RE: Request for HMSP Revision – MW-38 & MW-39 Iowa County Sanitary Landfill 48-SDP-02-79P

This letter is a request to modify the Hydrologic Monitoring System Plan (HMSP) by abandoning MW-38 and MW-39.

Phase B-1 Drawings

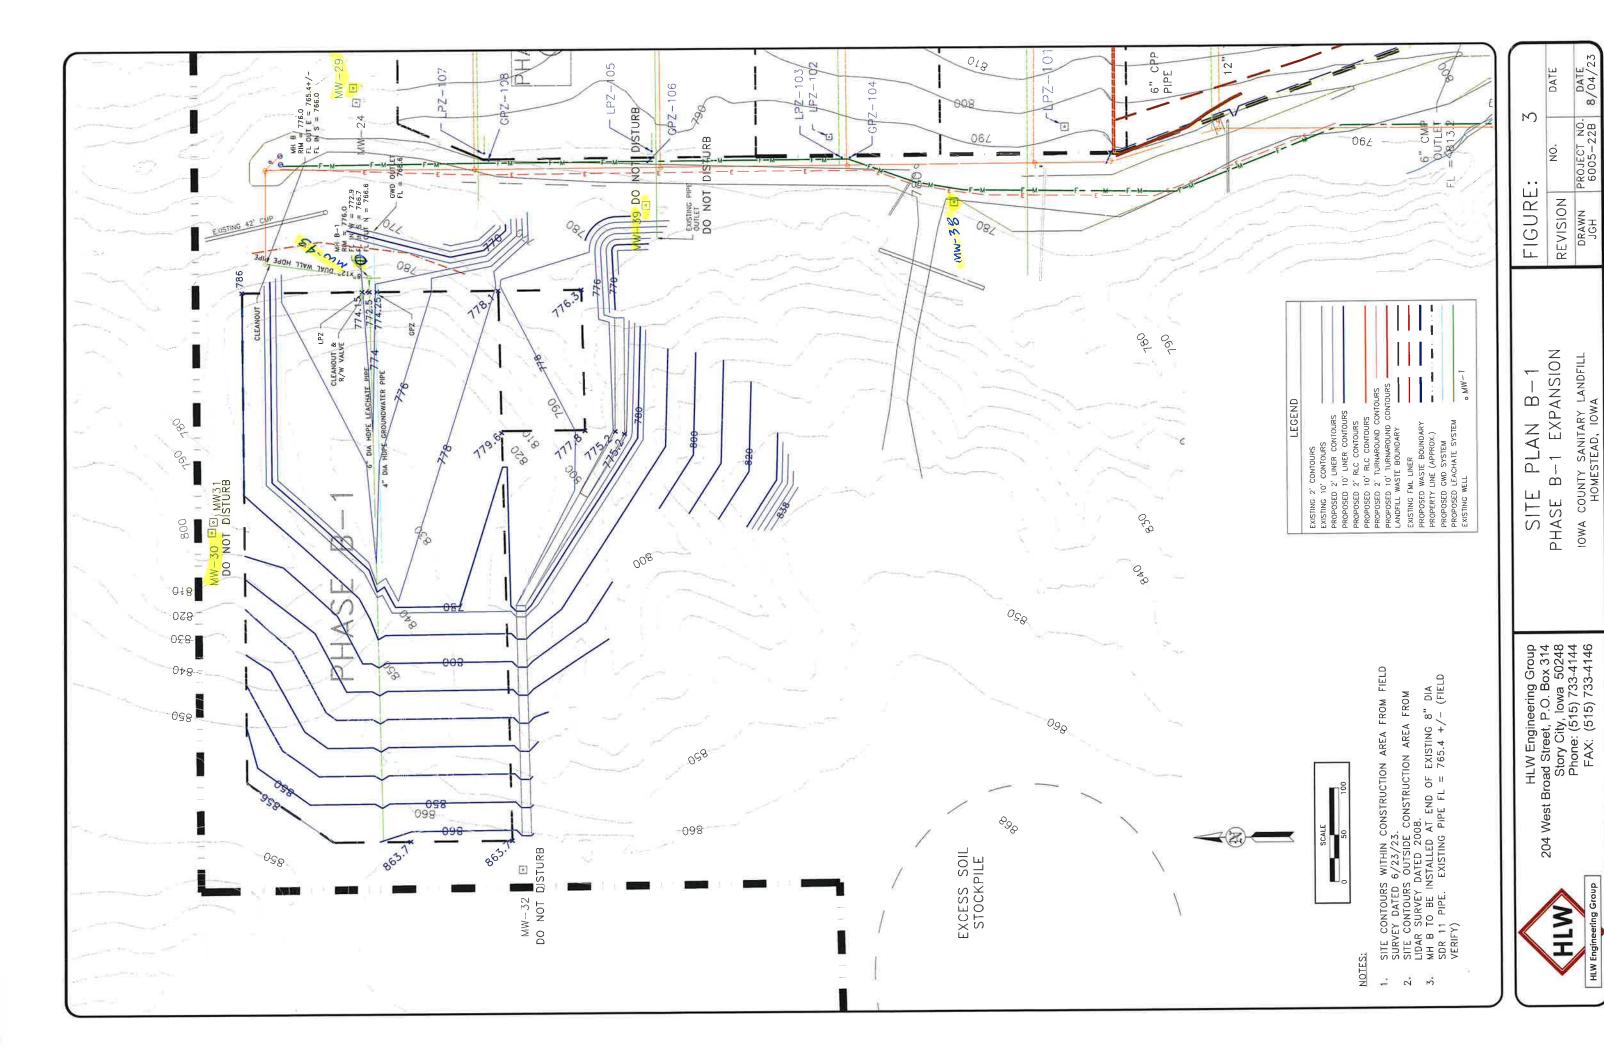
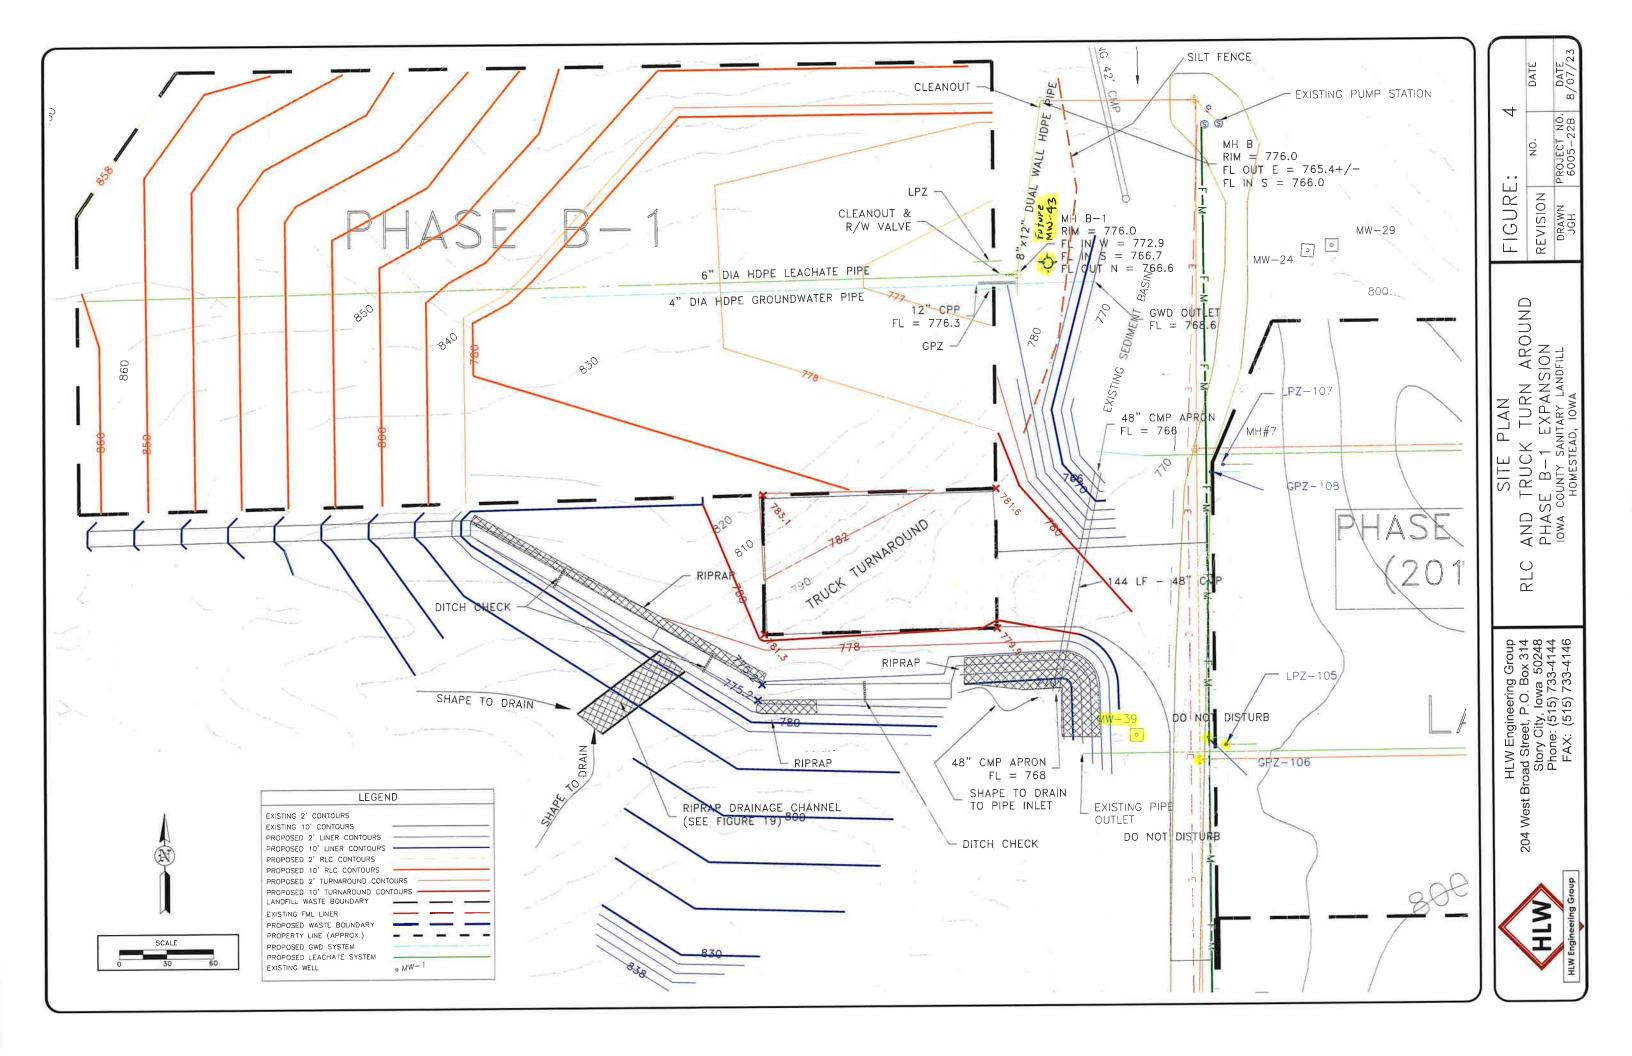
As illustrated on attached Figures 3 and 4 (Attachment A), MW-39 is located along the entrance road going to future Phase B-1. As construction in Phase B-1 is now on-going, it is apparent that MW-39 is in a high-traffic area and creates a "pinch point" in traffic flow into and out of the future cell (Figure 4, Attachment A). The width of the road between MW-39 and Phase A-4 leachate infrastructure (Manhole #6 and adjacent leachate head monitoring points LPZ-105/106) does not allow vehicles to pass side-by-side (traffic will be reduced to one lane).

Furthermore, when exiting Phase B-1, MW-39 is located on the inside of the turn on the blind-side of vehicles putting MW-39 in peril.

Based on the observed construction traffic to date, it seems most likely that MW-39 will be damaged by a vehicle(s) in the course of time.

We request that MW-38 and MW-39 be removed from the HMSP. It is proposed that MW-38 and MW-39 be properly plugged and abandoned in accordance with 113.10(2)"d" (over drilling and grouting from the bottom). Water quality compliance can still be documented at the downgradient boundary at monitoring wells MW-30, MW-43, MW-29D, and MW-40 in accordance with the currently accepted HMSP.

December 2023 Groundwater Contour Map

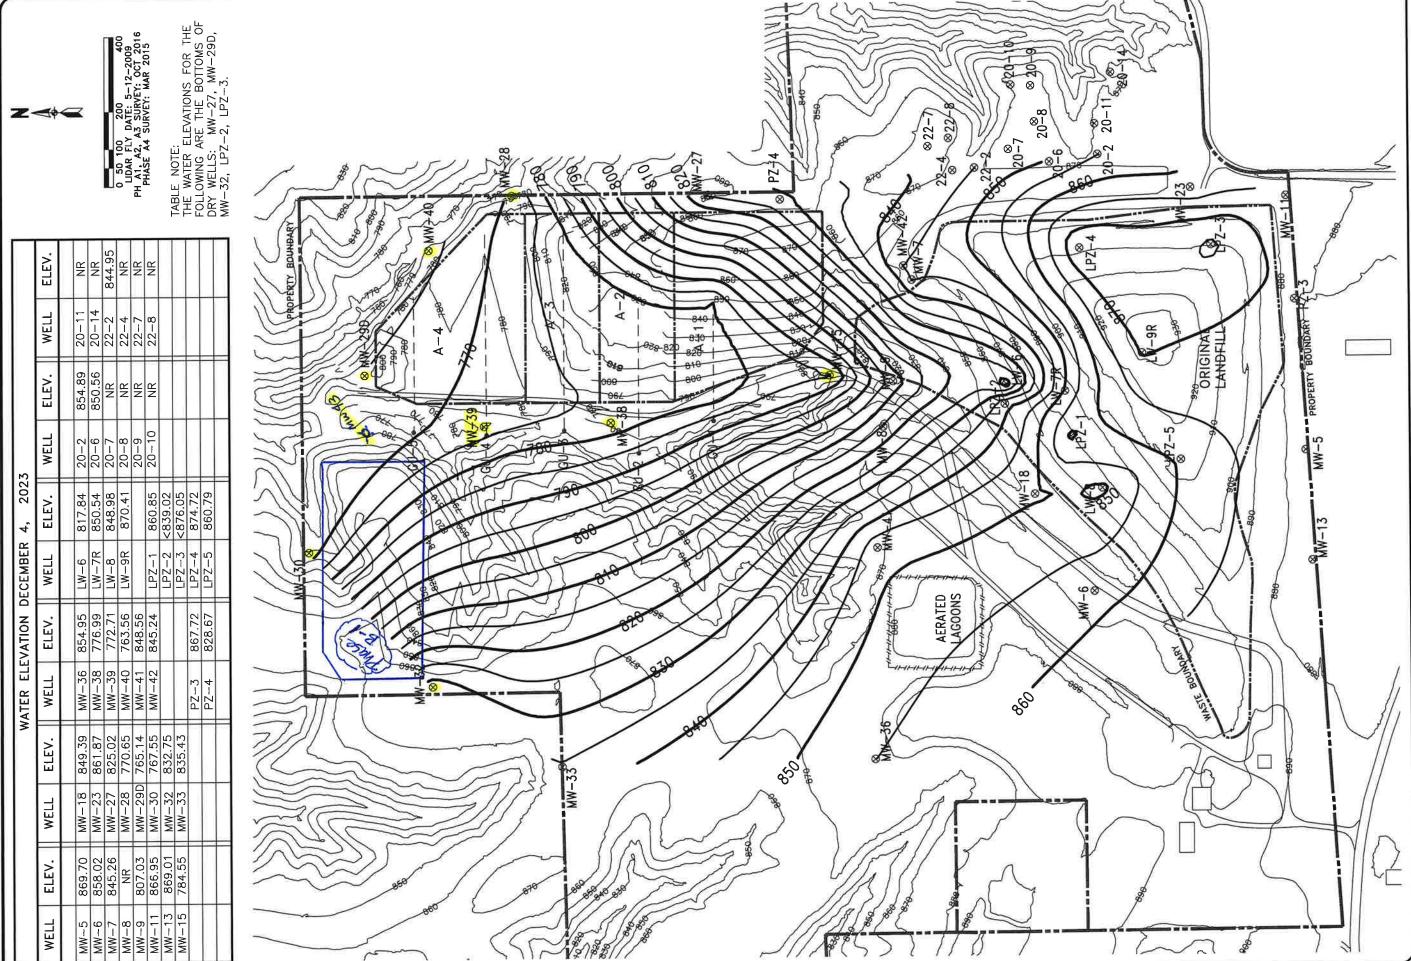
Observation of the Groundwater Contour Map (Fig 3 in Attachment B) illustrates flow patterns in the vicinity of MW-38 and MW-39. Groundwater from the Original Landfill converges to a point in the central ravine where MW-15 is located. Flow patterns in the ravine below the Original Landfill (near Phase A and Phase B) continues to trend inward to a point north of MW-39. Groundwater flow near the north perimeter of Area A and Area B is monitored at 300 foot spacing (113.10(2)"e"(2)) at monitoring wells MW-30, MW-43, MW-29D, and MW-40 (Figure 3, Attachment B).
